Up-dated Independent Assessment of Revised Basement Excavation Justification for Planning Application

Site	140-146 Camden Street London NW1 9PF
Client	London Borough of Camden
Date	April 2015
Our Ref	BIAREV/5130B

Figure 1: Extract from the Environment Agency’s map of ‘Risk of Flooding from Surface Water’.
 Ordnance Survey © Crown copyright 2014. All rights reserved. Licence No.100051531.

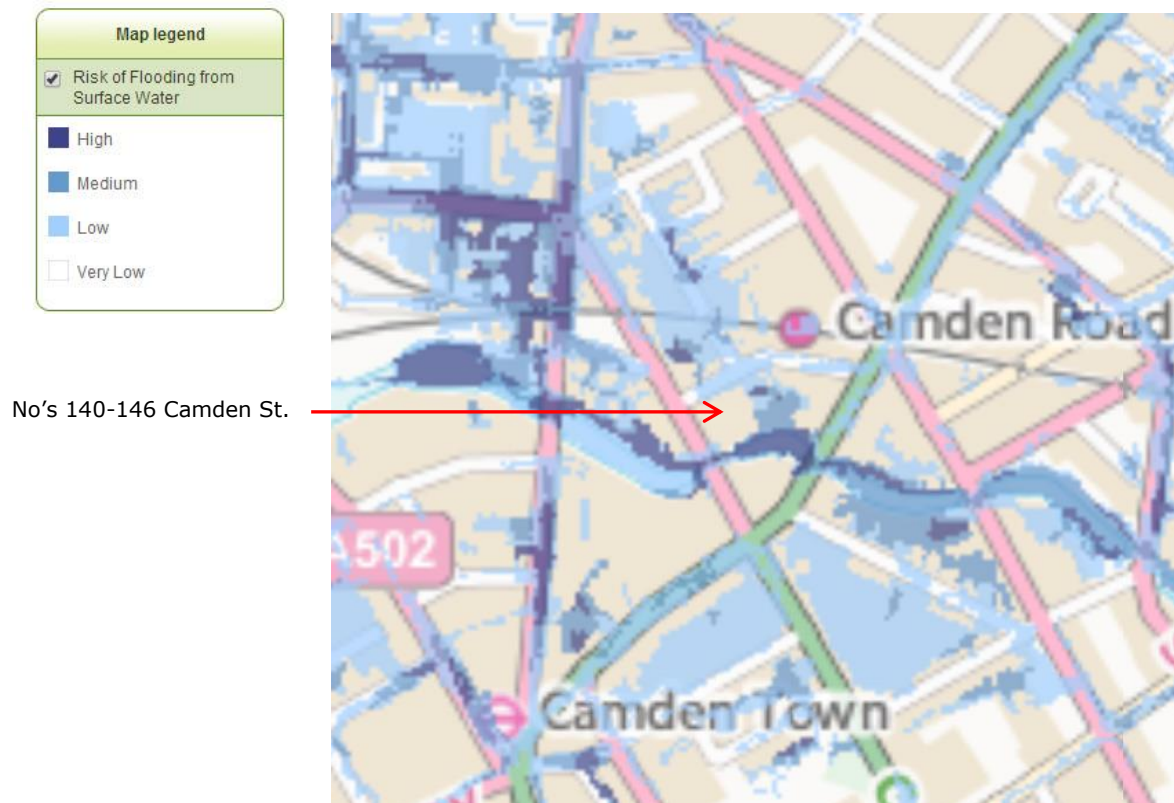
- 2.3.21 The Flood Risk Assessment claims that flood water is "*not expected to spill from the canal on to the tow path...*" because it is a managed waterway, and "*This is confirmed by the EA's map*". A larger extract from the EA's map (EA website, 2014) is presented in Figure 1 which shows that a 'High' risk of surface water flooding from the adjacent canal is predicted, including the towpath alongside the site of current interest. Appropriate flood resistance measures will therefore be required. Once again, provision of relevant details could be conditioned.

2.3.22 It is understood that the published Environment Agency map of surface water flood risk is less detailed than the full model, so the EA could be consulted for further details of the maximum predicted flood level of water from the canal.
